Access Compliance Report Public Rights-of-Way (Curb Ramps)

Main Street: BOLSA_AVE Cross Street: NEWLAND_ST Location: SE

ADA ID: RPRK220203142208 Ramp Type: Type 4 - Parallel Initial Pass/Fail: Fail Overall Compliance: No Severity Score: 16

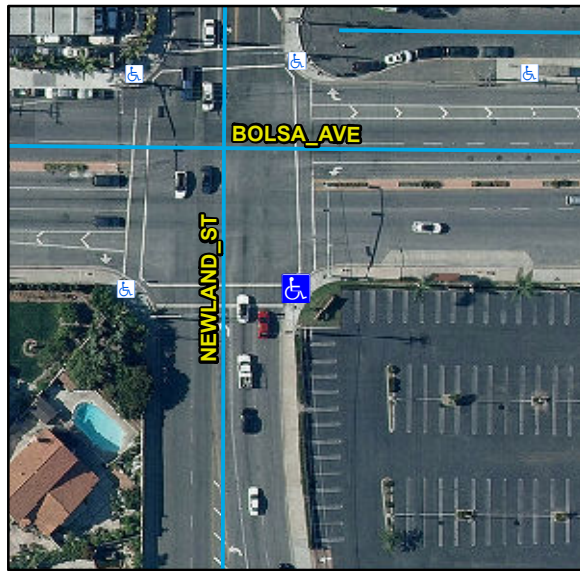
Compliance	Description	Data	Compliance	Description	Data
N/A	Ramp Length LT (in)	93	N/A	Ramp Length RT (in)	88
Yes	Ramp Width LT (in)	84	Yes	Ramp Width RT (in)	84
No	Ramp Run Slope LT (%)	9.4	Yes	Ramp Run Slope RT (%)	6.9
No	Ramp Cross Slope LT (%)	4.8	No	Ramp Cross Slope RT (%)	4.5
N/A	Landing Present	N/A	N/A	DWS Provided	N/A
N/A	Landing Length (in)	N/A	N/A	DWS Contrast	N/A
N/A	Landing Width (in)	N/A	N/A	DWS Length (in)	N/A
N/A	Landing Run Slope (%)	N/A	N/A	DWS Full Width	N/A
N/A	Landing Cross Slope (%)	N/A		DWS Offset Type	N/A
N/A	Landing Movement Obstructed?	N/A	N/A	DWS Offset Left (in)	N/A
	Landing Movement Type	N/A	N/A	DWS Offset Right (in)	N/A
N/A	Landing Shared	N/A			
N/A	Clear Space	Yes			
N/A	Clear Space To Crosswalk (in)	48			
N/A	Marked Crosswalk 1	Yes	N/A	Marked Crosswalk 2	Yes
	Crossing 1 Direction	N		Crossing 2 Direction	W
	Marked Crosswalk 1 Width (in)	144		Marked Crosswalk 2 Width (in)	144
N/A	Ramp Inside Crosswalk 1	Yes	N/A	Ramp Inside Crosswalk 2	Yes

Remove & Replace Curb Ramp With Two New Directional Ramps or Equivalent.
